Access Compliance Report

Public Rights-of-Way

Intersection ID: 53414	Main Street: WAVERLY_WALK_AV	Cross Street: SIX_MILE_CREEK_RD	Location: NW
ADA ID: B228060E86E9	Ramp Type: Perp	Initial Pass/Fail: Fail	Overall Compliance: No
Severity Score: 13.75			
Codes/Mitigation Info/Possible Solution		Field Measurements/Component Compliance

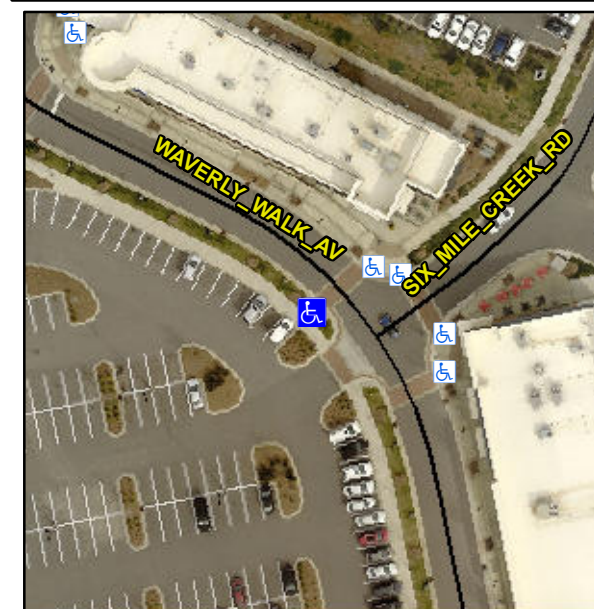
Not Found, R304.2.2, R304.5.3

Compliance	Description	Data	Compliance	Description	Data
N/A	Ramp Length (in)	96.0	No	Ramp Slope (%)	8.5
Yes	Ramp Width (in)	48.0	No	Ramp XSlope (%)	4.9
N/A	Flare Type LT	N/A	N/A	Flare Type RT	N/A
N/A	Flare Slope LT (%)	N/A	N/A	Flare Slope RT (%)	N/A
N/A	Flare Traversable LT?	N/A	N/A	Flare Traversable RT?	N/A
N/A	Landing Length (in)	N/A	N/A	DWS Provided?	N/A
N/A	Landing Width (in)	N/A	N/A	DWS Contrast?	N/A
N/A	Landing Slope (%)	N/A	N/A	DWS Length (in)	N/A
N/A	Landing X Slope (%)	N/A	N/A	DWS Full Width?	N/A
N/A	Landing Curb? (Y/N)	N/A	N/A	DWS Offset (in)	N/A
N/A	Shared Landing?	N/A			
N/A	Gutter Ponding?	N/A	N/A	Gutter Slope (%)	N/A
N/A	Gutter Lip Ht (in)	N/A	N/A	Gutter X Slope (%)	N/A
N/A	Painted X Walk1?	Yes	N/A	Painted X Walk2?	N/A
	X Walk 1 Direction	To NE		X Walk 2 Direction	N/A
N/A	X Walk 1 Width (in)	103.5	N/A	X Walk 2 Width (in)	N/A
	X Walk 1 Slope (%)	0.5		X Walk 2 Slope (%)	N/A
	X Walk 1 X Slope (%)	4.1		X Walk 2 X Slope (%)	N/A

Remove & Replace Entire Ramp.
